MARCH 25, 2024

ADDENDUM NO. 1

TO CONSTRUCT **BIRKHIMER EMERGENCY OPERATIONS CENTER (EOC)
UPGRADES AND IMPROVEMENTS
PROJECT NO.: CA-202313-C
TAX MAP KEY: 3-1-042:600
Honolulu, Oahu, HAWAII**

PB105

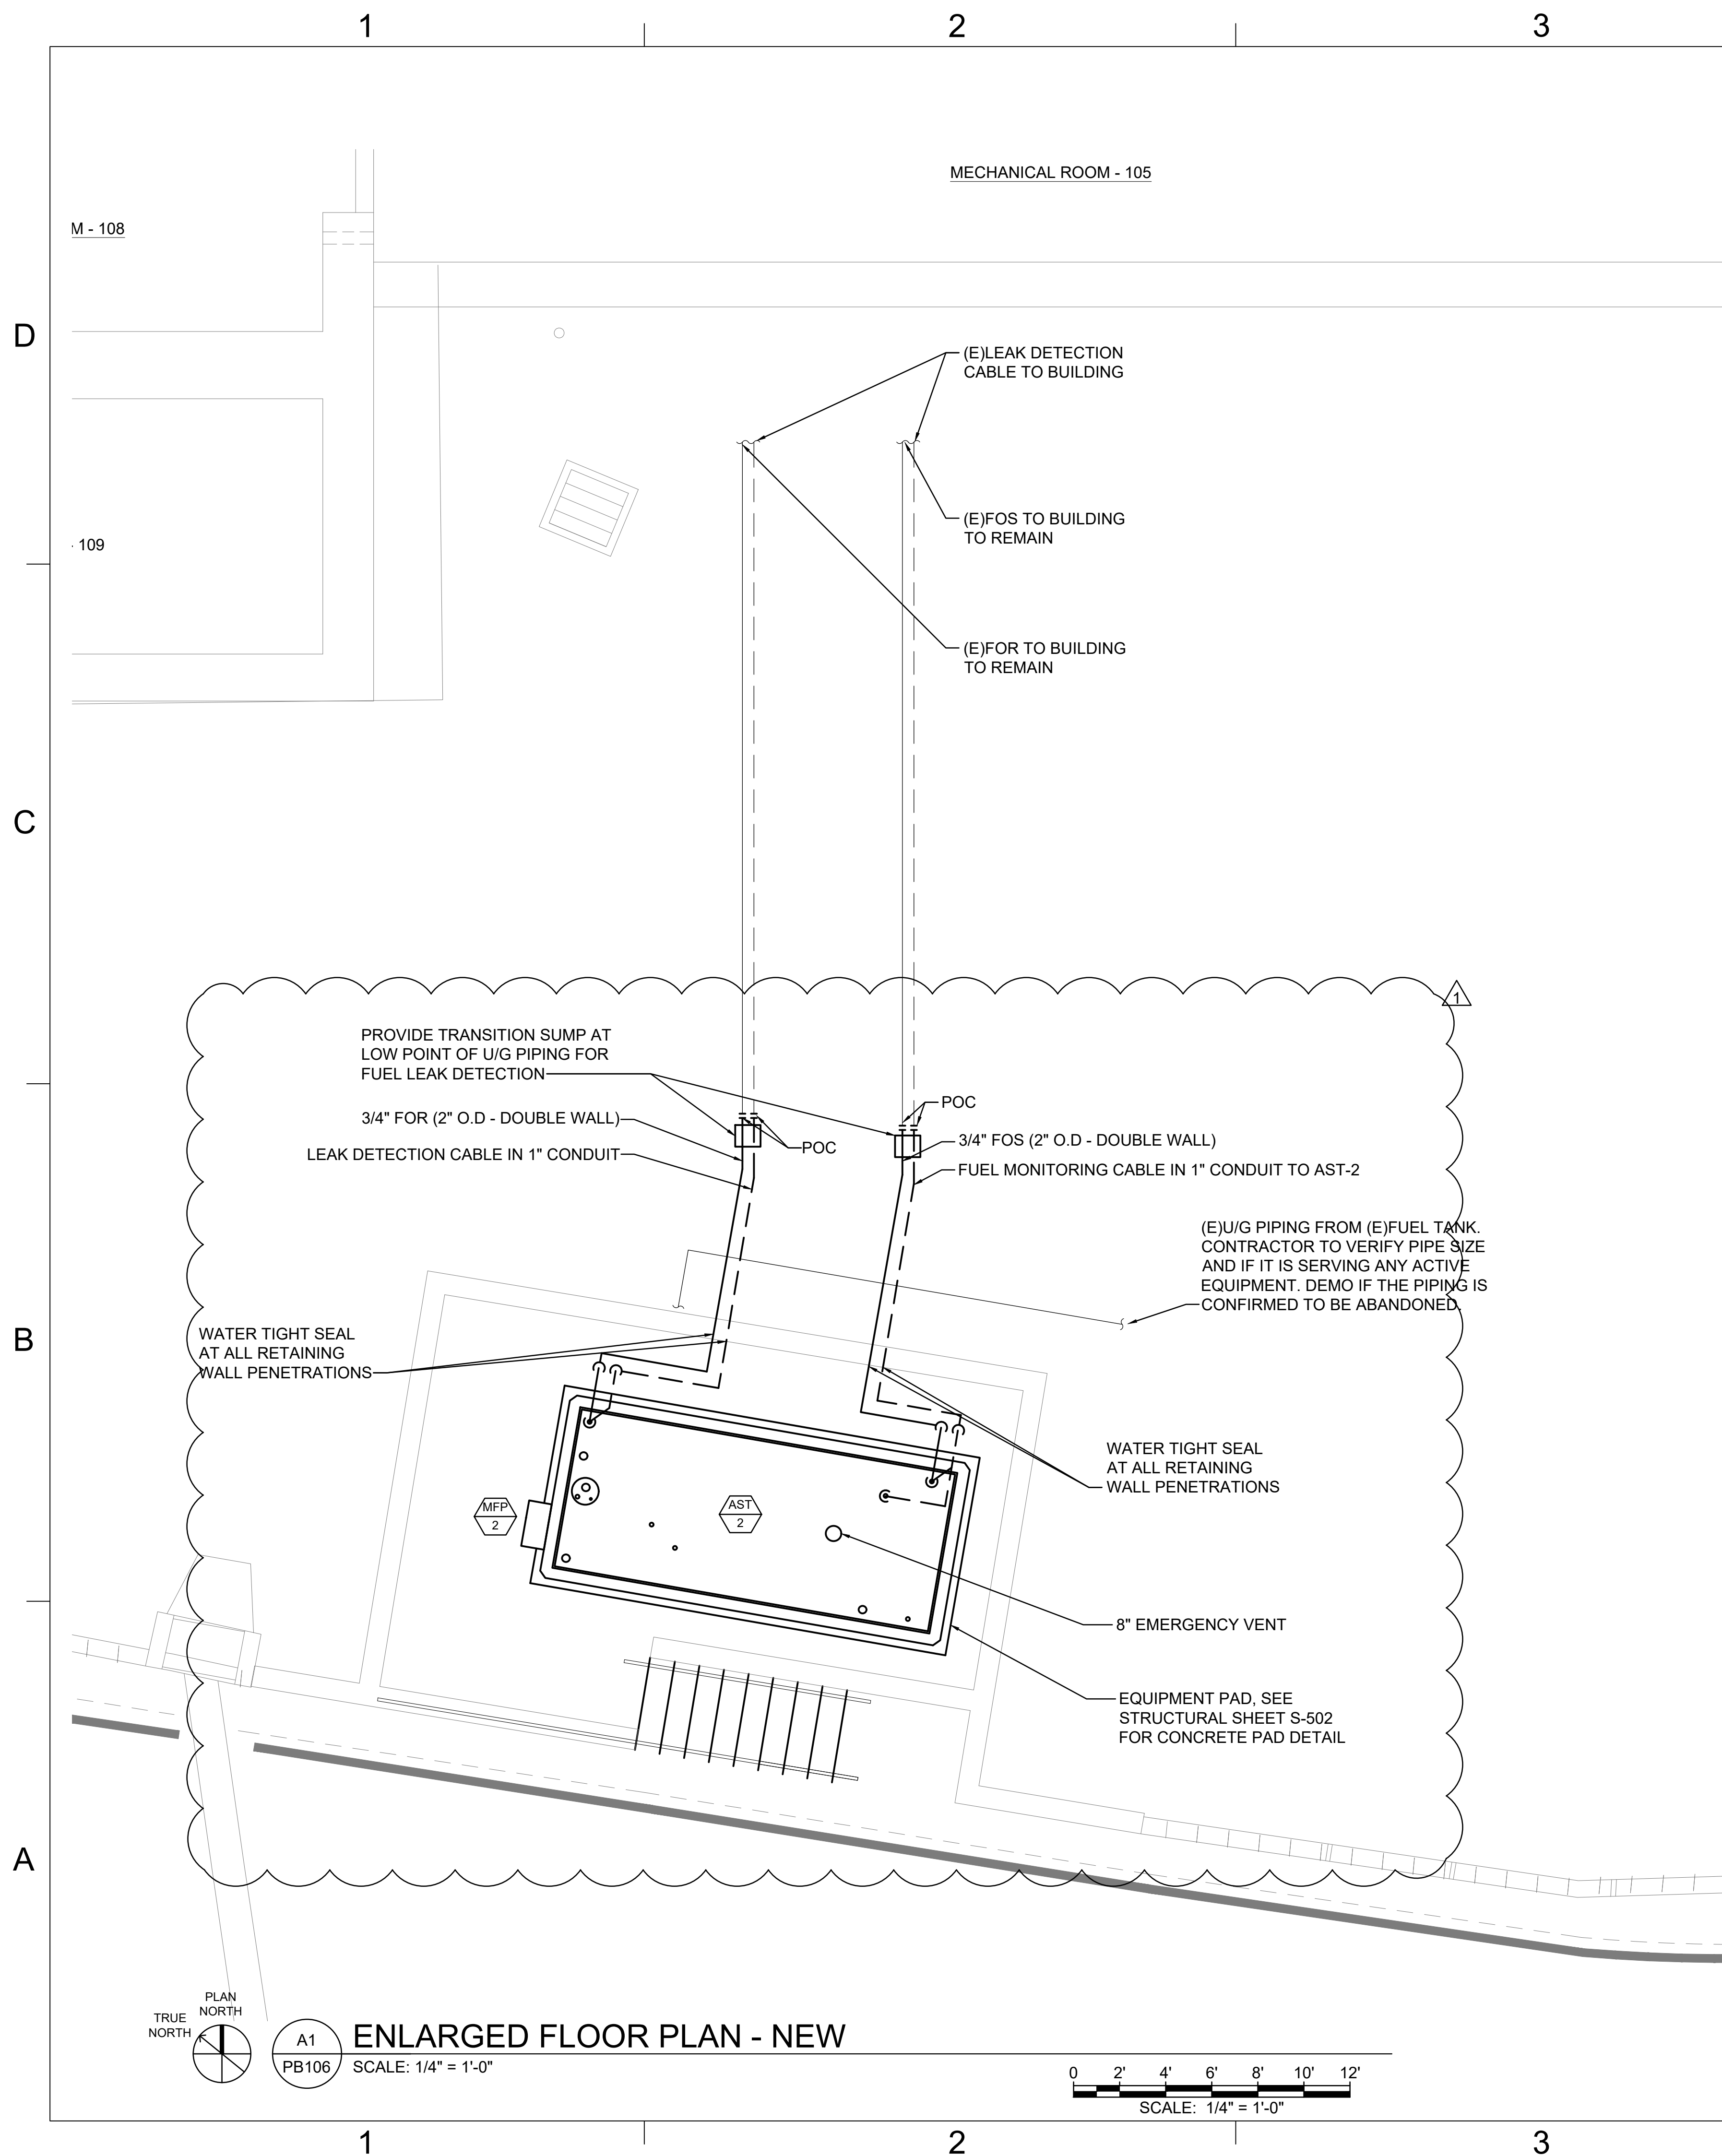
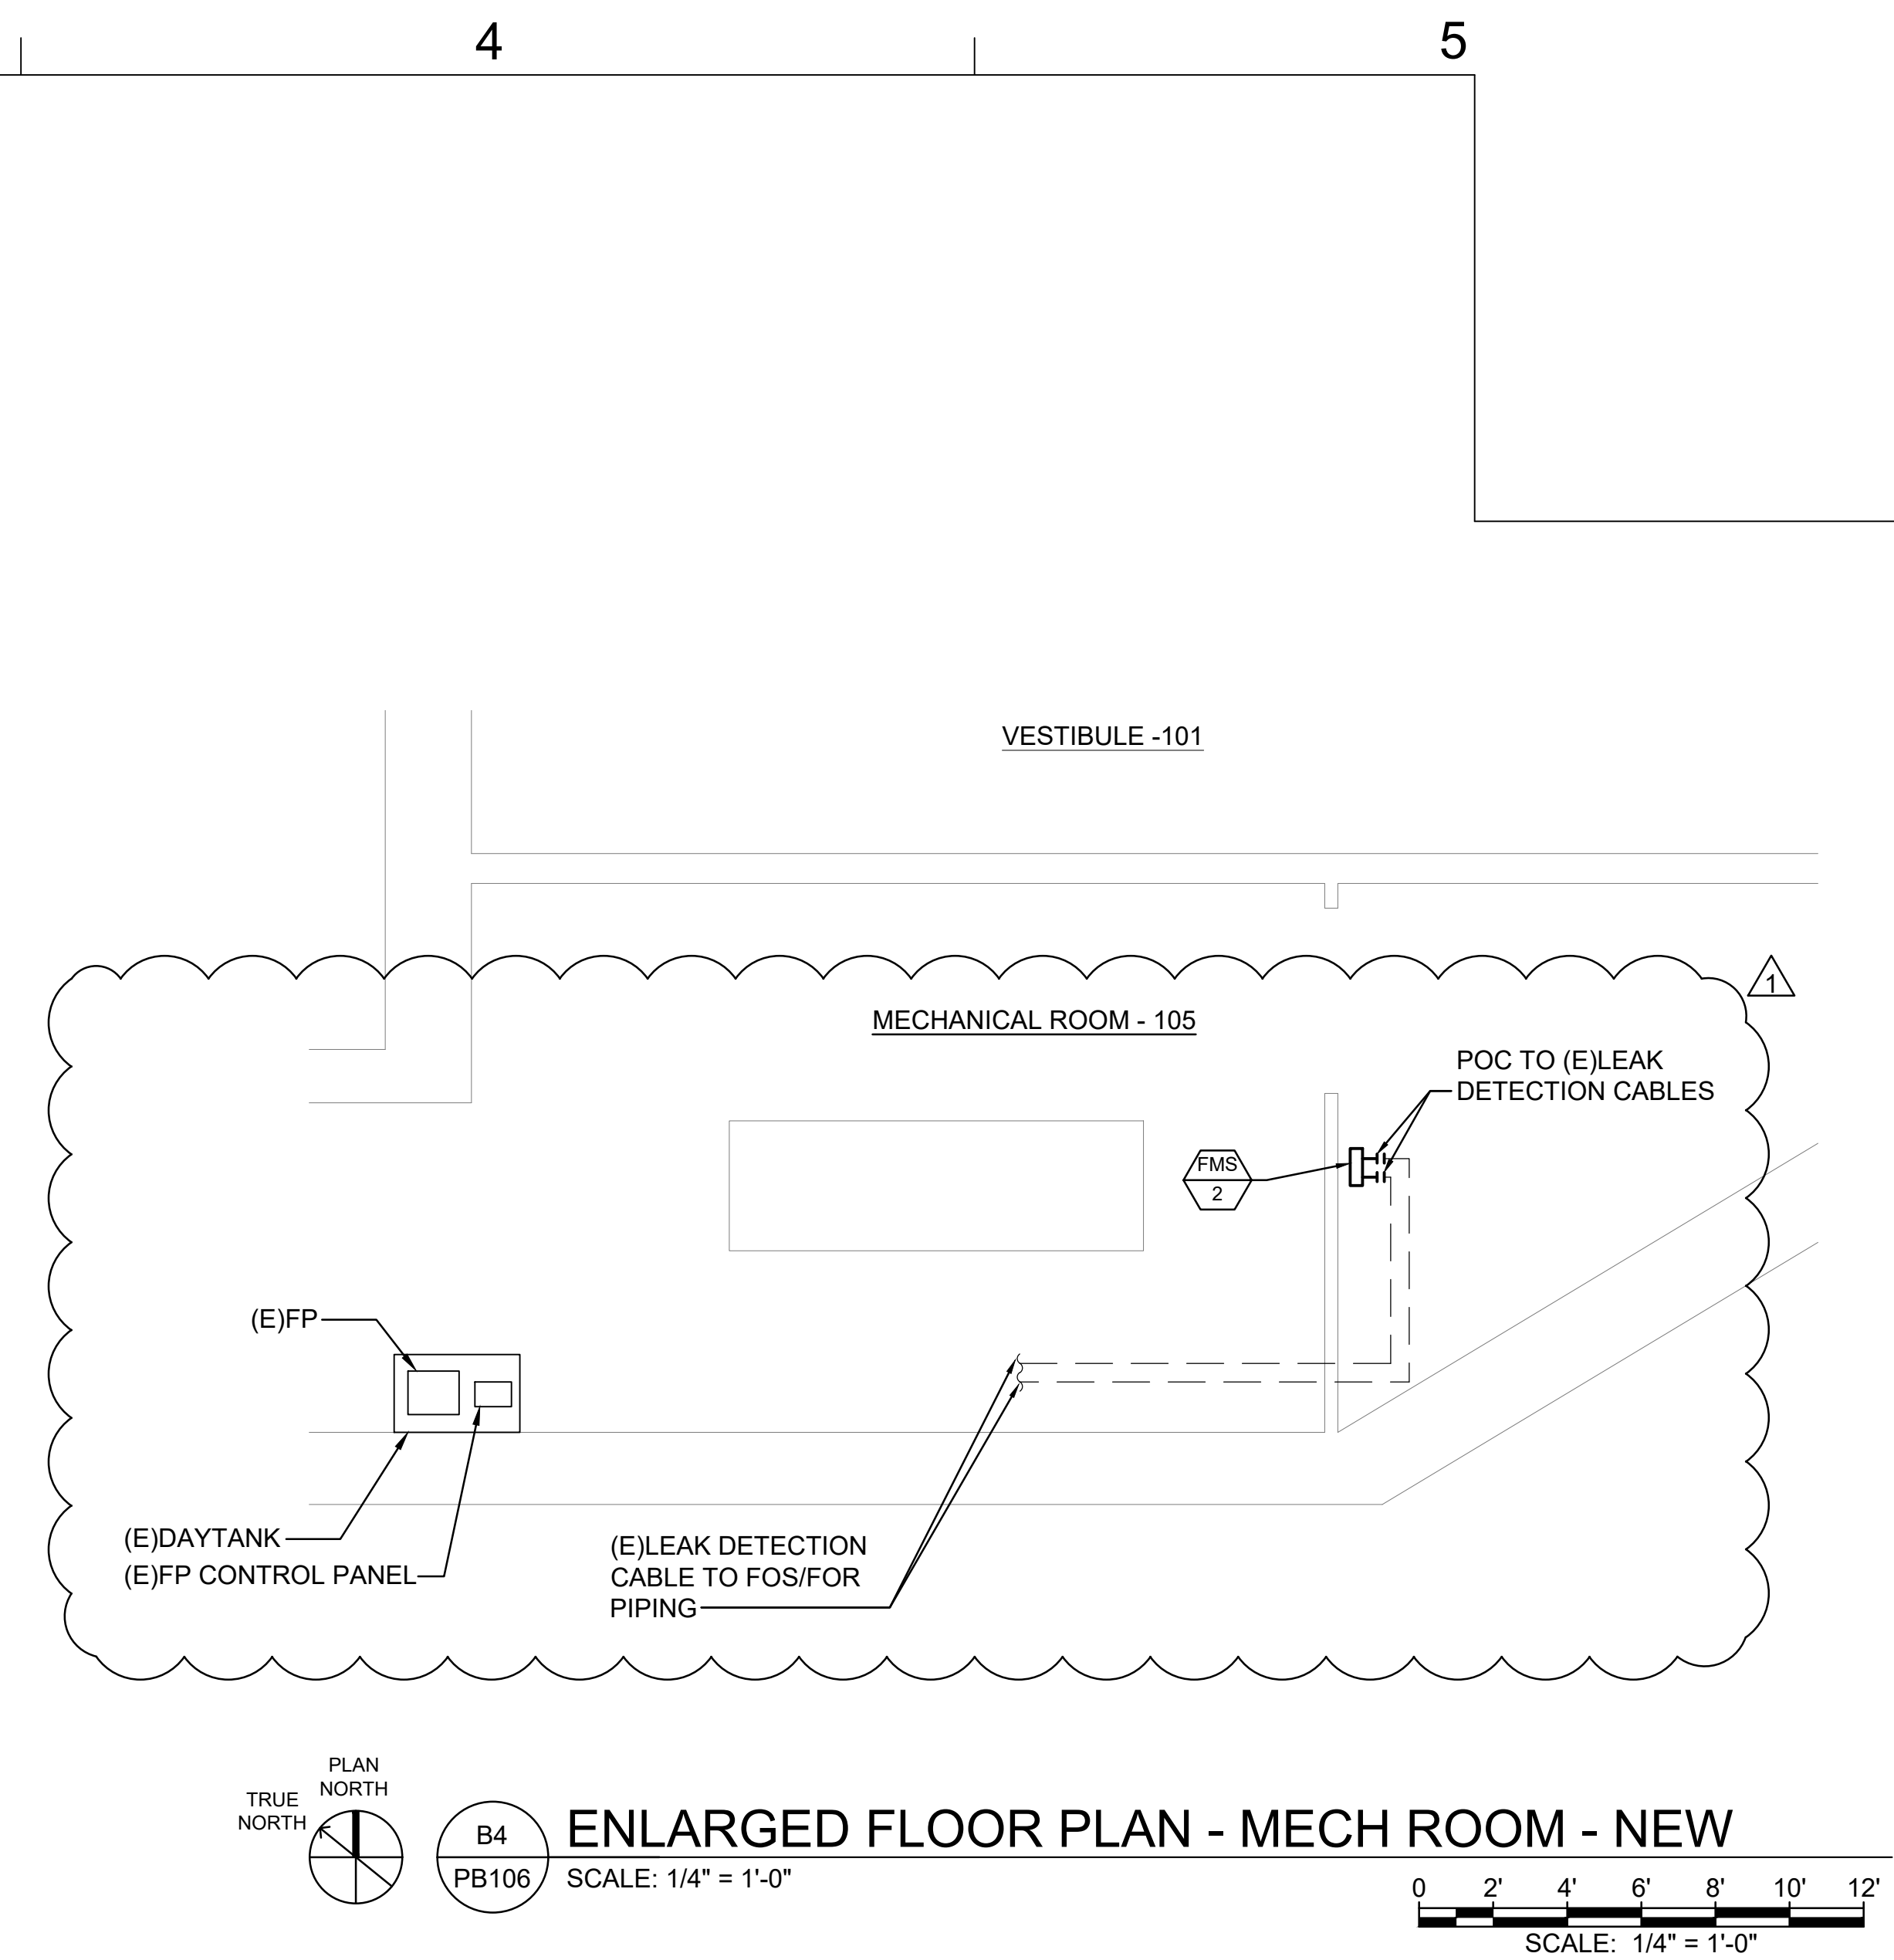
PLUMBING	PB105	<p>ENLARGED FLOOR PLAN – DEMO</p> <ul style="list-style-type: none"> • Revised phasing notes to include temporary fuel tank (AST-3) and fuel pump (FP-1) • Added location of temporary fuel tank (AST-3) and fuel pump (FP-1) to drawings. • Revised existing leak detection cable note • Revised drawings to show removal of the existing fuel monitoring panel • Added reference to civil for traffic control measure for the temporary fuel tank. • Added location of (E)fuel pump control panel for reference.
PLUMBING	PB106	<p>ENLARGED FLOOR PLAN – NEW</p> <ul style="list-style-type: none"> • Removed redundant fuel monitoring panel, revised drawings to show (1) new panel. • Added callout for transition sump • Added callout for reference to structural for AST-2 concrete pad • Revised location of AST-2
PLUMBING	PB401	<p>WATER STORAGE SYSTEM SCHEMATIC</p> <ul style="list-style-type: none"> • Revised WFS-1 sequence of operation • Revised UWST-1 schematic to include RPBP • Revised POL piping schematic. • Added sequence of installation for temporary fuel tank and fuel pump. • Revised sequence of operation for AST-2 to match the existing sequence.

6. Drawing PB105 Phase Notes 1.	
How much down time do we have to switch existing tank to new tank at the POC?	Downtime between switch over from existing tank to the temporary and/or new fuel tank shall be based on the capacity of the Daytanks located inside of the Birkhimer building (appx. 10 hours).

7. Drawing PB105 Key Notes Continued 5. Section 13200 Part 3.02.

Can you confirm what we are doing with fuel from existing tank?	Fuel from existing storage tank shall be recovered and reused in the new AST.
Can you provide estimated gallons to keep and reuse if fuel is not contaminated?	Approximately 4000 gallons
